WHAT WE HEARD:

RESPONSES:

Setback Studies

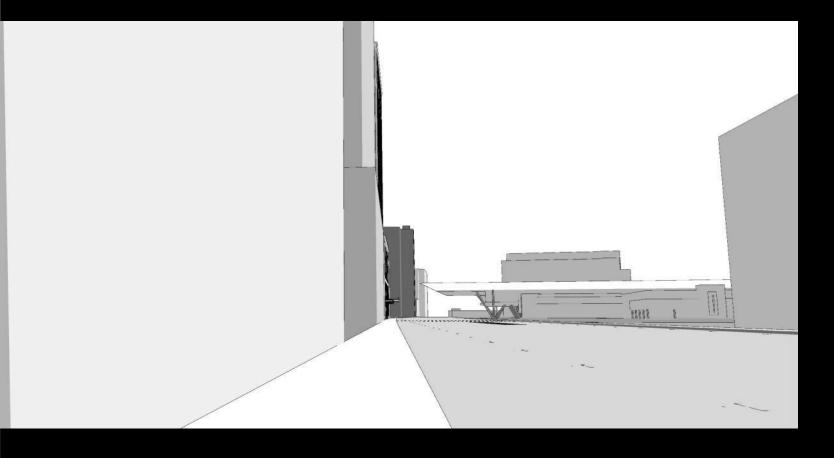
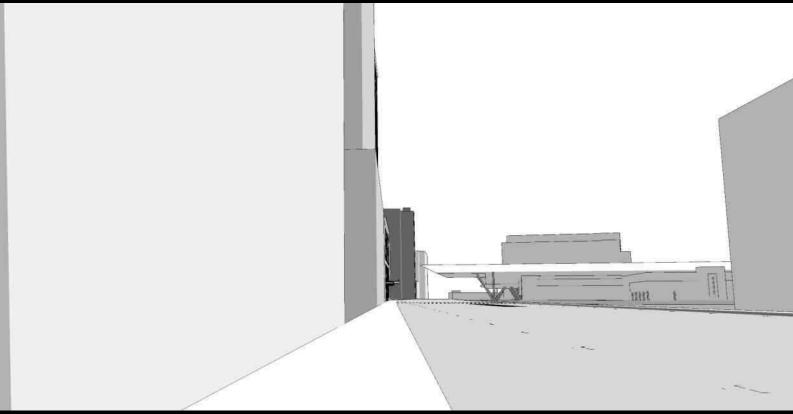
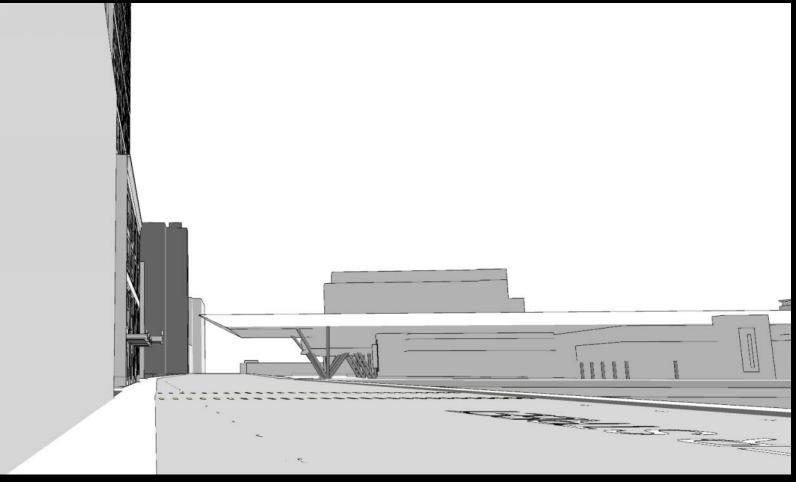
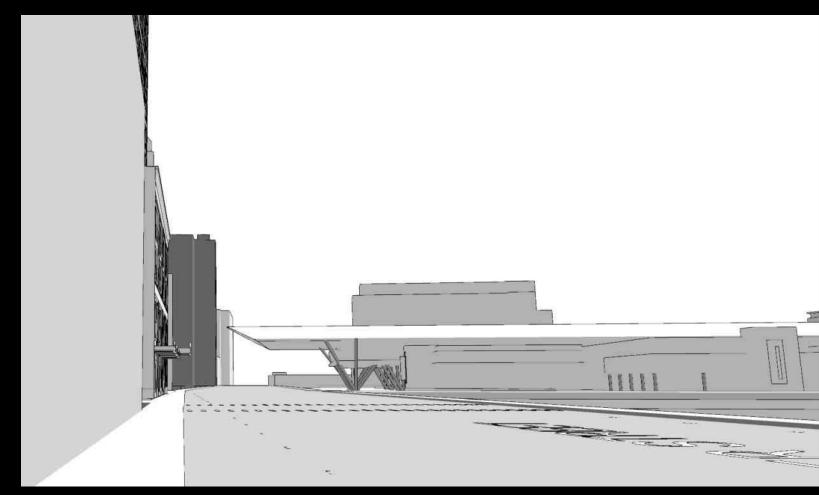
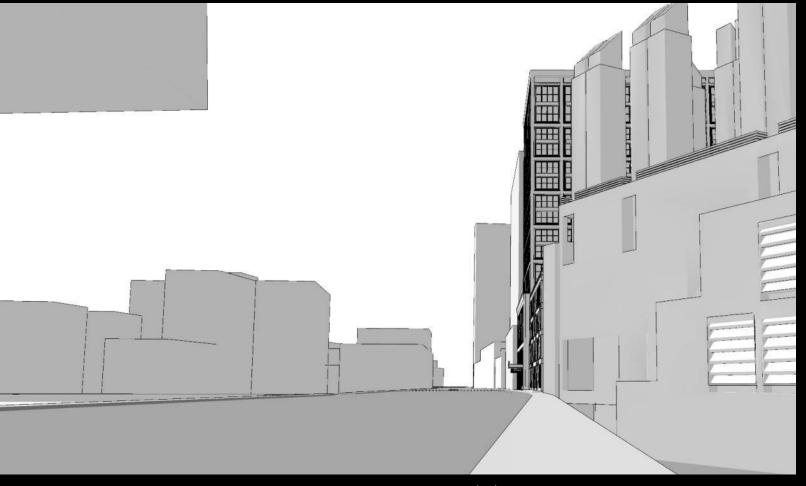
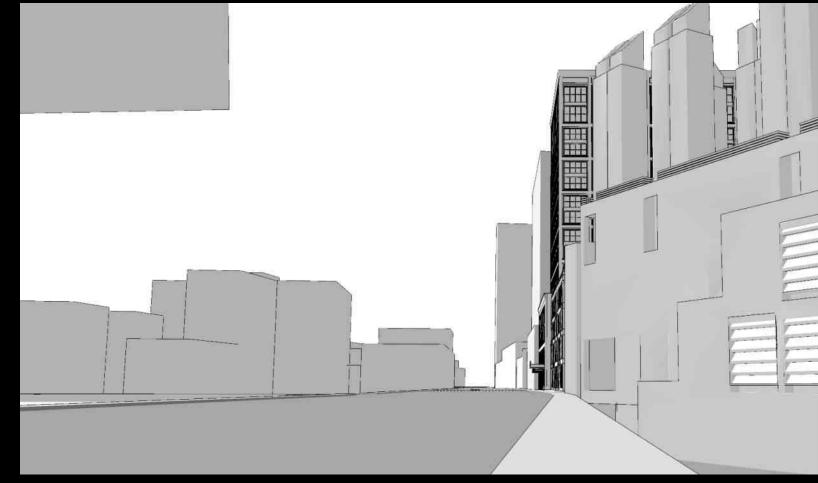
- Clarify relationship between building massing and approved zoning envelope.
- Study public perception of building from throughout the neighborhood.
- Clarify organizational hierarchy of building architecture and façade types.
- Study relationships and transitions between façade types.
- Study relationship between Summer Steps and retail storefronts.
- Study options for introducing more organic shapes into Summer Steps landscape design.

- Extensive study of building context both proximate and distant
- Extensive study of Congress Street facade options and massing alternatives
- Analysis of building hierarchy/logic vis a vis historical context
- Dimensional adjustments to enhance material transitions
- Adjustments to stair-facing retail storefront architecture
- Adjustments to public stair to improve human scale and quality of place
